SYDNEY WESTERN CITY PLANNING PANEL

REPORT: SWCPP Report

SUBJECT: 62-74 Canley Vale Road and 19-21 Phelps Street, Canley Vale

FILE No: DA 139.1/2025

Figure 8 – Proposed basement parking level

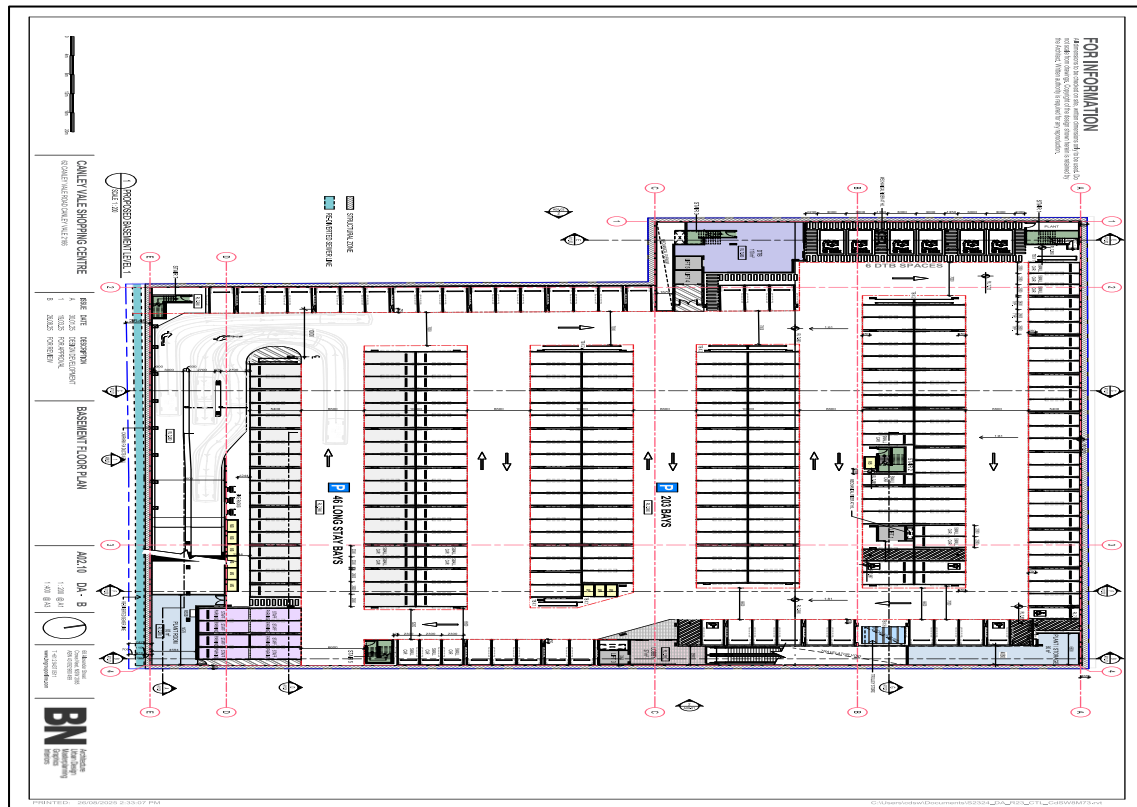
The design of the access driveway is not satisfactory in terms of entry and exit widths and driveway separation. The driveway width to the loading facility is insufficient to accommodate a heavy rigid vehicle.

- v. Loading bay access conflicts with the driveway to the basement;
- vi. The hours of operation of the carpark of 7am to 10pm is inconsistent with the 24hr operation of the gym and the grace period after night trading of restaurants has ceased;

- vii. Location of the motorcycle and bicycle parking is not satisfactory. Bicycle parking has been provided in the public domain which is not supported. Any bicycle parking must be on the site;

- viii. Accessible parking spaces need to be relocated to be proximate to the lift; and
- ix. Tandem spaces for staff are not supported due to difficulties in managing the use of those spaces in busy periods.

Motorcycle parking has been provided within the basement however is not in a convenient, legible location. Motorcycle parking should be in a designated area which is convenient and obvious. Further, stacked parking is provided for staff however is not supported on the basis that it can be difficult to manage the use of those spaces in peak times.

Figure 9 – Proposed ground floor plan – supermarket, retail and loading/servicing

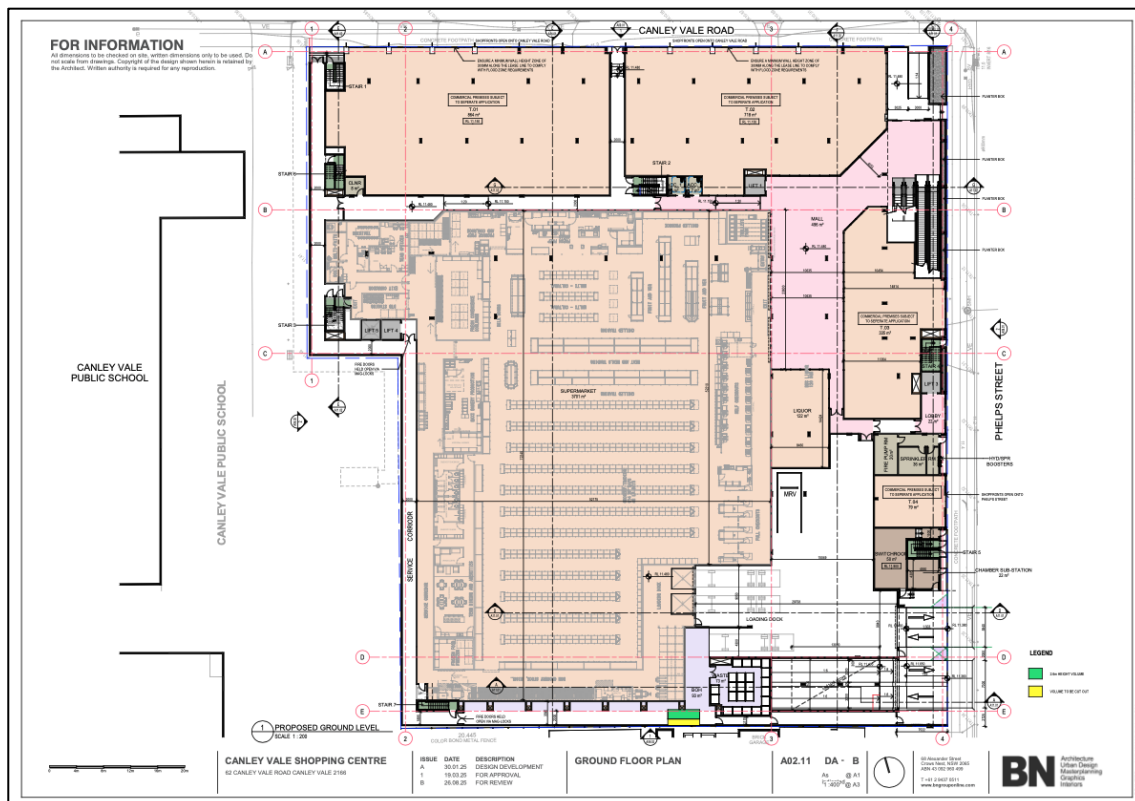
A freeboard level of 0.3m is achieved for most of the building except for the retail stores fronting Canley Vale Road which are below the 0.3m freeboard. Retail tenancies T.01 and T.02 would need to be raised to a floor level of RL11.18 to meet the 0.3m freeboard requirement.

Insufficient detail is provided to identify the supermarket waste storage areas. The Supermarket Waste Management Plan also fails to address the cleaning and maintenance of the supermarket garbage storage areas.

Figure 13 – Proposed south and west elevations

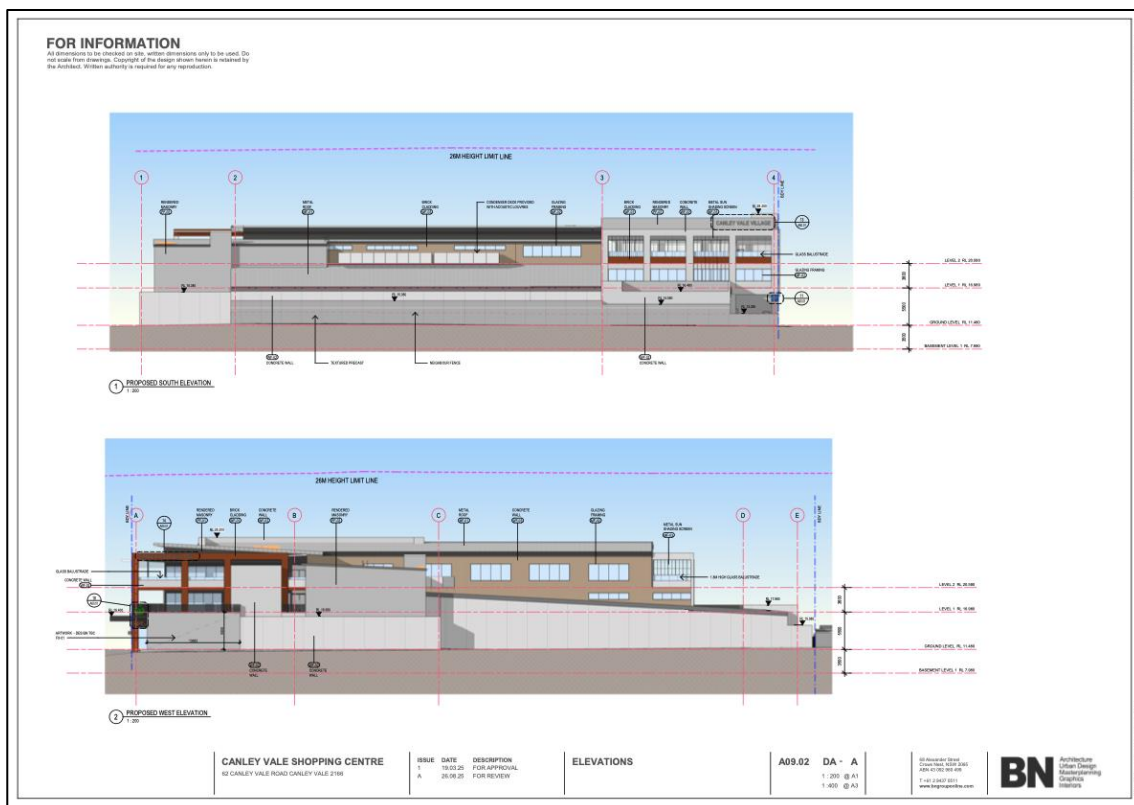
Further, the development proposes a 3.6m high wall along the southern boundary finished in a textured precast. The unrelieved expanse of wall along the boundary is not satisfactory with regard to its visual impact. This impact could be alleviated with a greater setback, a reduced wall height at the boundary and improved materiality.
